Access Compliance Report Public Rights-of-Way (Curb Ramps)

Main Street: N/A Cross Street: AIROSO_ST Location: SE

ADA ID: RPRK211203125458 Ramp Type: Type 3 - Combination 1 Initial Pass/Fail: Fail Overall Compliance: No Severity Score: 16

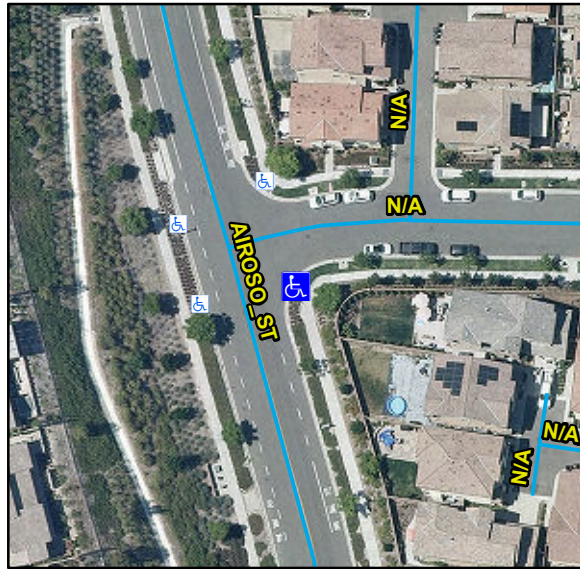
Compliance	Description	Data	Compliance	Description	Data
N/A	Ramp Length LT (in)	140	N/A	Ramp Length RT (in)	153
Yes	Ramp Width LT (in)	57	Yes	Ramp Width RT (in)	63
Yes	Ramp Run Slope LT (%)	6.5	Yes	Ramp Run Slope RT (%)	2.2
Yes	Ramp Cross Slope LT (%)	1	No	Ramp Cross Slope RT (%)	2.7
N/A	Ramp Length (in)	154	N/A	Flare Type LT	
Yes	Ramp Width (in)	62			N/A
No	Ramp Run Slope (%)	10.5	N/A	Flare Slope LT (%)	N/A
No	Ramp Cross Slope (%)	3.9	N/A	Flare Traversable LT	N/A
N/A	Landing Present	N/A	N/A	Flare Type RT	
N/A	Landing Length (in)	N/A			N/A
N/A	Landing Width (in)	N/A	N/A	Flare Slope RT (%)	N/A
N/A	Landing Run Slope (%)	N/A	N/A	Flare Traversable RT	N/A
N/A	Landing Cross Slope (%)	N/A	N/A	DWS Provided	N/A
N/A	Landing Movement Obstructed?	N/A	N/A	DWS Contrast	N/A
	Landing Movement Type	N/A	N/A	DWS Length (in)	N/A
N/A	Landing Shared	N/A	N/A	DWS Full Width	N/A
N/A	Clear Space	Yes		DWS Offset Type	N/A
N/A	Clear Space To Crosswalk (in)	N/A	N/A	DWS Offset Left (in)	N/A

Remove & Replace Curb Ramp With Two New Directional Ramps or Equivalent.
